Nikonos-III

REPAIR MANUAL (Revised-2)

NIPPON KOGAKU K.K.

Figure 3

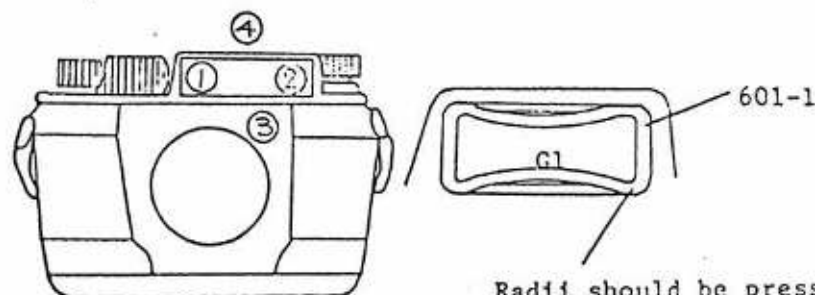
- 3) Position P/N 601-1 in place in the following sequences.
 - a) Clean the both surfaces of G1 and install in place.
 - b) Thinly coat P/N 601-1 with grease G6252 and install P/N 601-1, first pressing the shorter side ① and ② as illustrated in Figure 3. The radii at the four corners should be pressed down in place at this step. Also, note that P/N 601-1 should be positioned with its G1 side kept toward you to prevent G1 from chipping off.

- c) Press down the longer sides at the center, first ③ side, then ④.
 - d) Inspect the P/N 601-1 for even seating.
 - e) Performing the water pressure test, clean the G1 surface with ether to see if no blur appears on the G1 surface. If detected, water leakage is possible, therefore, repeat the P/N 601-1 positioning procedures from the step (1).

Radii should be pressed when shorter sides set in place

Figure 1 Takeup Stopper Lever

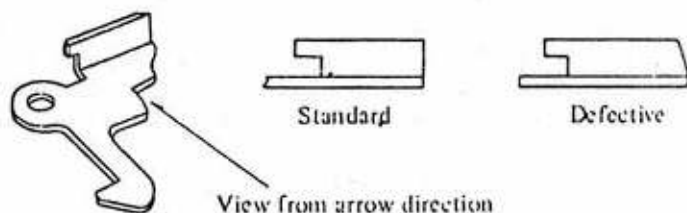
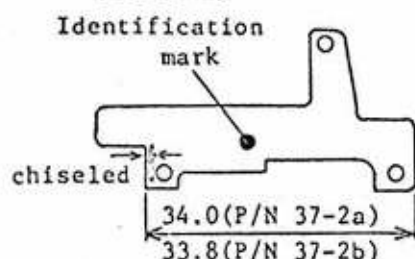
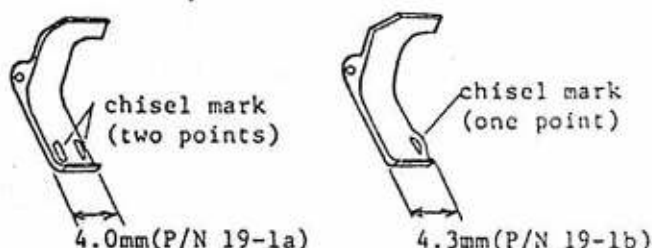
Normally, if one tries to turn the takeup lever backward while it is in the return process, the takeup stopper lever (P/N 111) engages the takeup stopper ratchet (P/N 110-1) to stop the reverse movement. However, if the gap between P/N 110-1 and the frame counter base plate (P/N 301-1) is too great, the takeup stopper ratchet will rise up, allowing the takeup stopper lever to slip under it. The lever and ratchet then disengage, freeing the takeup lever to turn in the film-advance direction and causing insufficient shutter cocking. Defective takeup stopper levers and loose takeup stopper lever axles (P/N 118) are also apt to cause similar situations.

Description	Part No. (P/N)		Qty	Ref Assy	T/S	Remarks
	Former	New				
Rack Retainer	37-2	37-2a	1	A5-1a	△	Modified. From one kind into two
		37-2b	1	A5-1b	△	
L-Shaped Lever	19-1	19-1a	1	A3	○	Modified From one kind into two
		19-1b	1	A3	○

Figure 2 Modified Unit

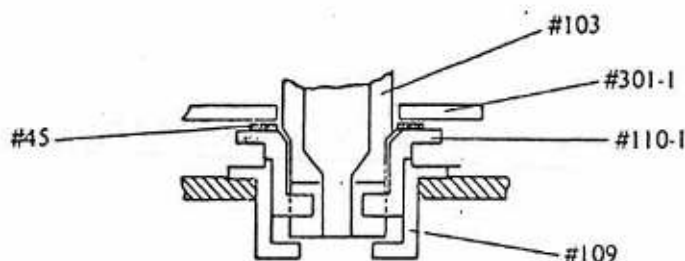
- To solve the trouble, a 0.2-mm washer has been inserted between P/N 110-1 and P/N 301-1 to prevent P/N 100-1 from rising up (Fig. 2), and P/N 111 from slipping beneath P/N 110-1.

Description	Part No. (P/N)		Qty	Ref. Subassy.	T/S	Remarks
	Former	New				
Washer	—	145	1	F-1	○△	Added

When servicing is required for the trouble covered in this report, insert a washer as specified above. If P/N 111 has slipped beneath P/N 110-1, the bottom of the ratchet (P/N 110-1) and the pawl end may be damaged. If so, replace these parts and then modify as detailed above. For defective P/N 111 or loose P/N 118, replace or tighten respectively.

Figure 1 Modified Frame Counter

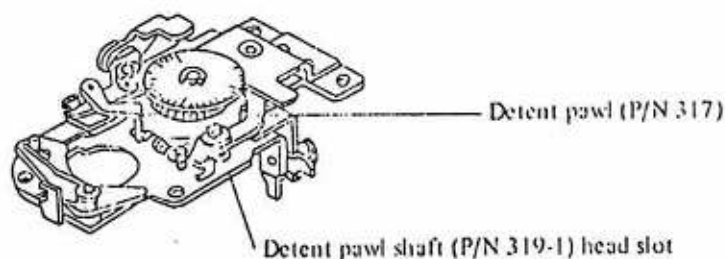
1. To solve condition 1, "Failure to advance from zero (0)," the shape of the frame counter ratchet (P/N 304) has been changed, which eliminates poor frame counter advancing caused by poor stopper position, and facilitates installation of the frame counter spring.
2. To solve condition 2, "Failure to move from a certain digit halfway between 0 and 36," the counter reverse auxiliary lever unit has been modified and the detent pawl spring (P/N 318), counter reverse lever spring (P/N 327), and auxiliary lever spring (P/N 333-1) have been strengthened. These measures also help solve condition 3.
3. To solve condition 3, "Failure to reset," eccentricity has been given to the detent pawl shaft, facilitating the adjustment of the advance pawl.

Replace old frame counter subassembly D with a new, modified one. For easier identification of a new subassembly, look for a slot in the detent pawl shaft head of the frame counter subassembly (Fig. 1).

Figure 2 Adjustment of Detent Pawl

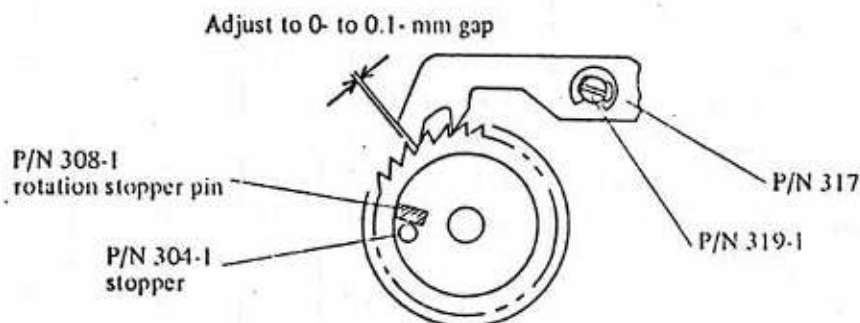
To adjust the detent pawl (P/N 317) to provide proper clearance between P/N 317 and P/N 304-1, first set the P/N 304-1 stopper against the rotation stopper pin (P/N 308-1). In this position, adjust the eccentric detent pawl shaft (P/N 319-1) so that the detent pawl (P/N 317) engages the ratchet (P/N 304-1) and the gap between the pawl and ratchet will be of a standard clearance of 0 to 0.1mm. (Fig. 2).

Figure 2 Modified Unit

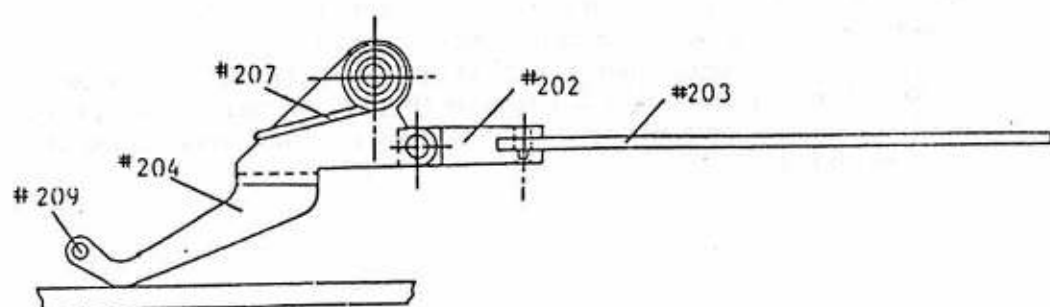
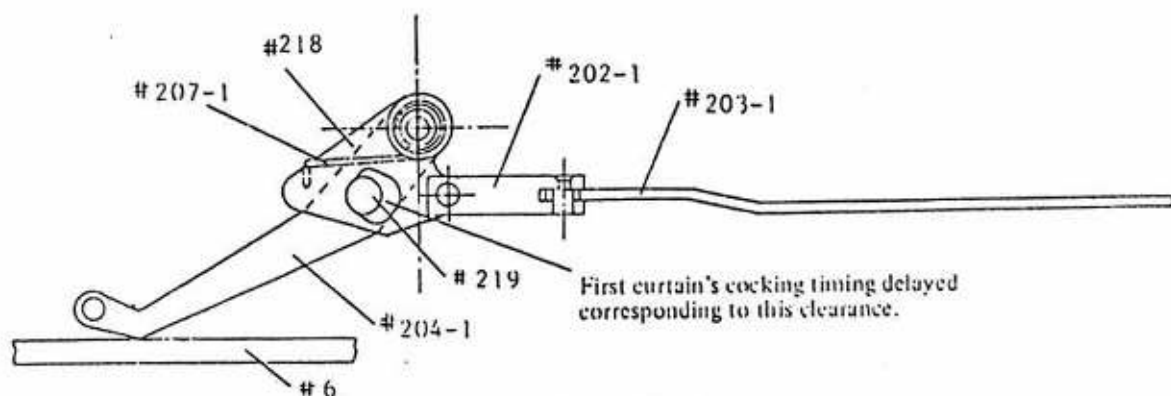
The charge lever (P/N 204) directly coupled to the film-advance lever has been modified to consist of two component parts; charge lever A and B, designated P/N 218 and P/N 204-1 respectively. The two parts have been positioned with a newly-installed charge eccentric pin (P/N 219). As a result, in the new cameras, the timing to cock the first curtain with the charge lever (P/N 204-1 and P/N 218) has been delayed. This ensures the completion of the second curtain's travel before the first curtain's cocking starts, after the film-advance lever springs outward to certain angles. Also, adjusting the eccentricity of P/N 219 prevents P/N 204-1 from striking P/N 6, thus ensuring proper shutter cocking and release.

Description	Part No. (P/N)		Qty	Ref. Subassy.	T/S	Remarks
	Former	New				
Inner housing	4	4	1	F-1	Δ	Access hole drilled
Aperture aux. plate	39	39	1	F-1	○Δ	Access hole drilled
Universal joint	202	202-1	1	E18-1	Δ	Sideways dimension shortened
Coupling lever	203	203-1	1	E18-1	Δ	Modified
Charge lever B	204	204-1	1	E18-1	Δ	Modified
Charge lever holder	205	205-1	1	E18-1	Δ	Modified
Charge lever spring holder	206	206-1	1	F-1	○Δ	Lengthened
Charge lever spring	207	207-1	1	F-1	○Δ	Modified
Charge lever A	—	218	1	E18-1	Δ	Added
Charge eccentric pin	—	219	1	E18-1	Δ	Added
Charge washer	—	220	1	E18-1	Δ	Added

When a Nikonos III camera has been brought in for servicing for the trouble covered in this report, first determine if the camera was produced before or after the modification. If produced before modification, replace old parts with P/N 206-1, P/N 207-1 and 1:18-1 in combination. Note that old inner housing (P/N 4) and aperture aux. plate (P/N 39) need not to be replaced with new ones since the only difference between the old and new ones is the access hole.

Figure 1 Frame Counter Unit

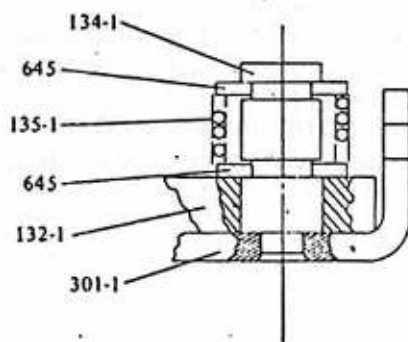
To solve the slippage of P/N 107 under P/N 132, P/N 132 has been thickened from 0.8 mm to 1.5 mm, with related modifications of the associated parts.

Description	Part No. (P/N)		Qty	Ref. Subassy.	T/S	Remarks
	Former	New				
AR lever	132	132-1	1	D	○△	Modified
AR lever bearing	133	—	1			No longer used
AR lever axle	134	134-1	1	D	△	Modified
AR lever spring	135	135-1	1	D	○△	Modified
AR middle lever pin	137	137-1	1	D	△	Modified
Snap ring A	645	645-1	1	D, F-1	○△	Modified
Frame counter base plate assembly	D1	—				Included as assembly D, thus no longer available
AR lever assembly	D7	—				
AR middle lever assembly	D8	—

When servicing is required for the trouble covered in this report, replace the old frame counter unit (assembly D) with a new one. Note that the new assembly letter remains the same.

Figure 1 Modified Bottom Plate Unit.

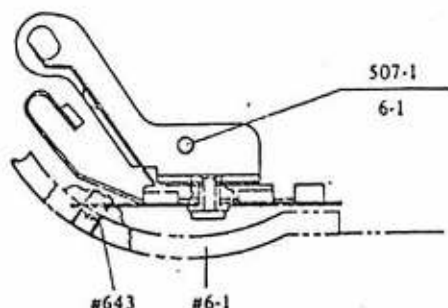
To solve these problems, part's modifications have been performed, effective June 1977, providing the following improvements:

The former bottom plate unit subassembly (Assy. C) and new one (Assy. C-1) are not interchangeable. Therefore, when a Nikonos III camera has been brought in for servicing of the FP contact, first determine whether the camera was produced before or after this modification. New cameras can be readily identified from the newly installed screw (P/N643) as shown in Figure 1. By turning P/N643, adjust the time lag or contact efficiency to the Nikon standard. (see Repair Manual 9F3B-R. 2028.B p. 30 item 19)

Description	Part No. (P/N)		Qty	Ref. Subassy.	T/S	Remarks
	Former	New				
Bottom plate	6	6-1	1	C-1	Δ	Modified
Insulating tube	60	—	1	—		No longer used
FP synch A contact	501		1	C-1	Δ	Modified
FP grounding contact A		501-1	1			
FP synch B contact	502		1	C-1	Δ	Modified
FP grounding contact B		502-1	1			
Contact rivet	503		1	C-1	Δ	Modified
FP contact rivet		503-1	1			
Insulating A-plate	505		1	C-1	Δ	Modified
FP insulating plate		505-1	1			
Insulating A-ring	506		1	C-1	Δ	Modified
FP Insulating ring		506-1	1			
A-ring rivet	507		1	C-1	Δ	Modified
FP grounding contact A rivet		507-1	1			
B-ring rivet	508		1	C-1	Δ	Modified
FP grounding contact B rivet		508-1	1			
Insulating B-ring	509	—	1	C-1		No longer used
FP synch grounding	510		1	C-1	Δ	Modified
FP synch contact		510-1	1			
FP insulator	—	532	1	C-1	Δ	Added
FP synch contact adjusting screw	—	643	1	C-1	○ Δ	Added
FP contact lead wire	517	517-1	1	C-1	○ Δ	Lengthened
Bottom plate unit subassemblies	C	C-1				Modified

Figure 2

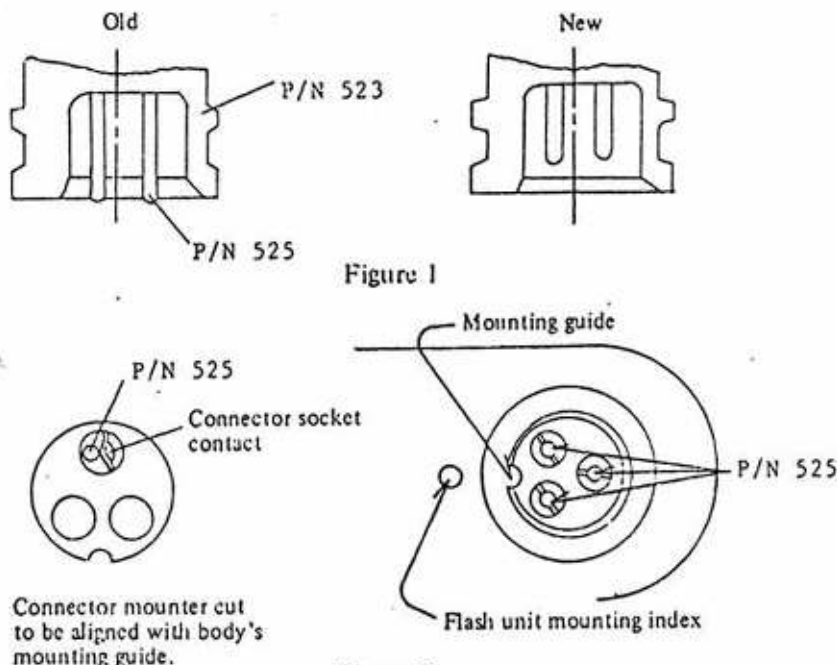
With Nikonos III cameras bearing serial No. before 310600, the synch contact shafts (P/N 525) protrude above the synch terminal mount (P/N 523). Therefore, when disconnecting the Flash Unit Adapter or Underwater Flash Unit P from the camera body, the tips of P/N 525 may still remain inside the connector socket contacts even when the connector mount (9FA11G3 P/N 37) comes apart from P/N 523. Also, when mounting the flash unit or adapter on the camera body, P/N 525 may accidentally enter into the space between one of the connector socket contacts and the surrounding insulator part, without the connector mount cut aligned with camera's flash unit or adapter mounting guide. If excessive force is applied to the connector mount to remove or mount the unit in these situations, P/N 525 is likely to bend or break, or the black, plastic part of the connector mount is likely to break. To solve this, the synch contact shafts have been shortened by 1.1 mm and the chamfer of the synch terminal mount has been reduced by 0.5 mm. Note that the part numbers of the two parts remain unchanged.

When servicing is required for the trouble covered in this report, replace P/N 525 and synch contact cover assembly B2 with modified ones.

Subject: Shutter Speed Adjusting Mechanism modification

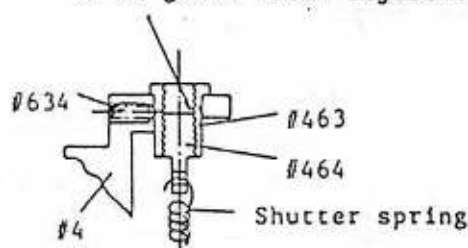
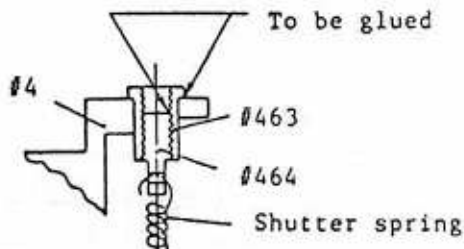
After shutter speed has been adjusted by rotation of shutter spring adjusting ring(P/N 463), P/N 463 is secured by set screw (P/N 634) to maintain the proper speed. However, to reduce the production cost, still maintaining the original performance, modified ring(P/N 463) will be glued in place with LOCTITE after completion of shutter speed adjustment. This change will be effective April 1978.

to be glued after adjustment

To be glued

Description	Part Number(P/N)		Qty	Ref Assy	T/S	Remarks
	Former	New				
Inner housing	4	4	1	F-1	△	Screw hole for P464 removed
Shutter spring Adjusting ring	463	463	2	F-1	○△	Modified
Set Screw	464	-	2	F-1	○△	Obsolete

Subject: Spool Mechanism parts modification

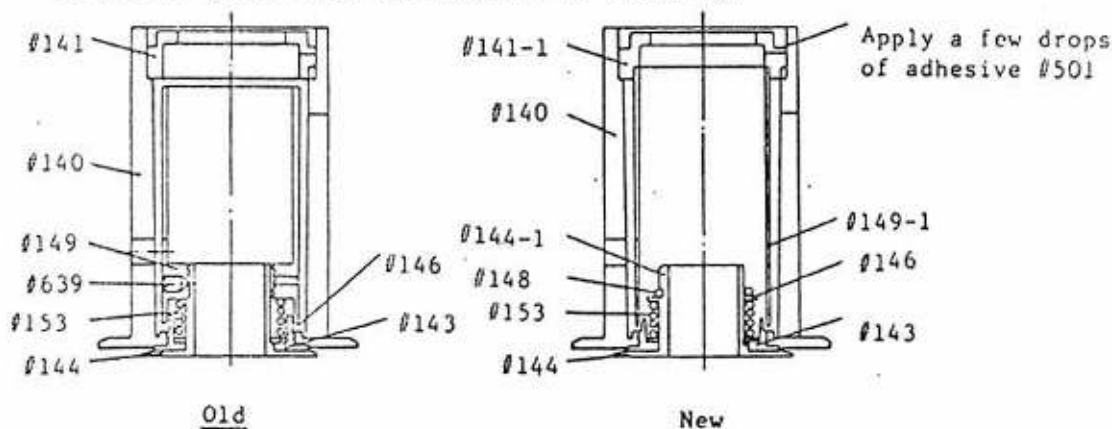
Spool friction adjustment is indispensable to install the present Spool assembly(E2) for smooth film-take-up operation, thus requiring very precise and complicated assembling procedures. To simplify the assembling procedures and to reduce the production cost, Spool assembly has been modified so as to be installed without a friction torque adjustment after assembling. With this modification, Spool friction of 160 - 240g can be pre-adjusted only by assembling the individual component parts into the complete E2 assembly.

Description	Part Number (P/N)		Qty	Ref Assy	T/S	Remarks
	Former	New				
Spool upper bearing	141	141-1	1	F-1	○△	Modified
Spool Ratchet	144	144-1	1	E2	○△	Modified
Take-up spring sleeve	146	146	2	E2	○△	Qty increased
Retaining spring	-	148	1	E2	○△	Added
Set screw	149	149-1	1	E2	○△	Modified
Friction Spring Ring	639	-				Obsolete

When Nikonos III camera has been brought in for general repair requiring replacement of Spool component parts, it is recommended to replace the old E2 assembly with new one. When installed, be sure to apply a few drops of adhesive between P/N 140 and P/N 141-1 to secure the new E2 assembly in place.

Fig. 1

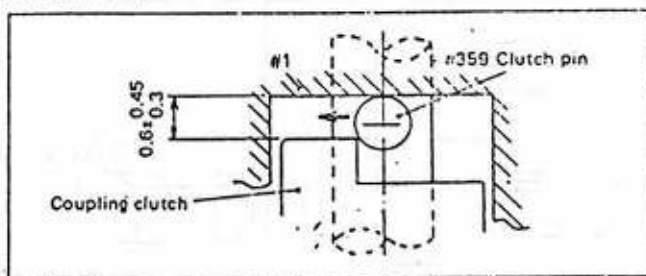
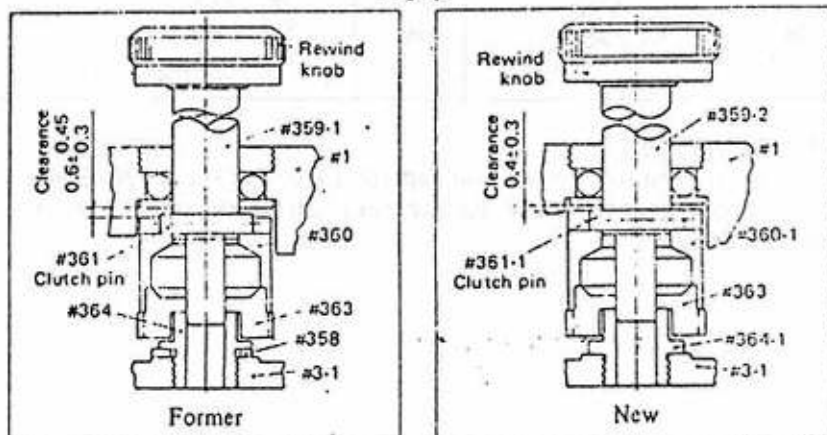
- (1) The clearance between Top Cover P/N 1 and Coupling Clutch P/N 360 tends to become larger than the diameter of Clutch Pin P/N 361 due to the accumulation of tolerance deviations in various components; this causes P/N 359 to enter through the clearance.
- (2) When the rewind knob is pulled up, and then turned in order to "shove in" P/N 359, the clutch pin engages the coupling pin and then pushes P/N 1 up; this results in the rewind knob "running idly." (See Figures 1 and 2)

To prevent the above from recurring in the future, the accumulation of deviations in tolerances has been decreased. The diameter of the clutch pin has been enlarged, and other associated parts have likewise been modified (see Parts Change Table). In like manner, P/N 364 has been modified, and P/N 358 has altogether been discontinued.

Description	Former		New		Q'ty	Sub-ass'y No.	T/S	Remarks
	P/N	Figure	P/N	Figure				
Rewind shaft	359-1		359-2		1	E-13-1	○△	Modified
Coupling clutch	360		360-1		1	E-12-1	△	Modified
Clutch pin	361		361-1		1	E-13-1	○△	Modified
Rewind shaft washer	358				1			No longer used
Rewind gear	363		363-1		1	E-12-1	△	Modified
Rewind gear shaft	364		364-1		1		○	Modified

When servicing is required, be sure to replace E-12, E-13 and P/N 364 all at the same time. The difference between new parts and former ones can be determined by measuring the diameter of Clutch Pin P/N 361.

Figure 1

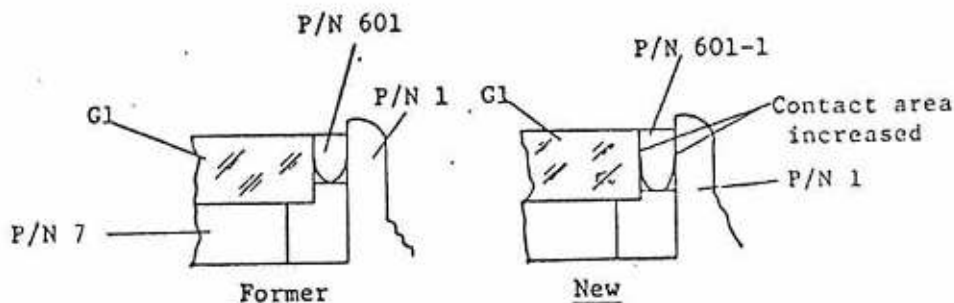
To secure the G1 lens in place, new Finder Housing(P/N 7) has been thinned by 0.5mm than old part, although part No. remains unchanged. Also, G1 packing has been thickened by 0.5mm, designated P/N 601-1. With the modification of these two parts, G1 and P/N 601-1 can contact each other in the wider area than before, thus securing G1 in place more tightly; G1 in new Nikonos III camera can endure the pressure difference of 0.76Kg/cm at maximum.

Description	Part Number(P/N)		Qty	Ref Subassy	T/S	Remarks
	Former	New				
Finder Housing	7	7	1	A1	○△	Modified
G1 Packing	601	601-1	1	A	○△	Modified
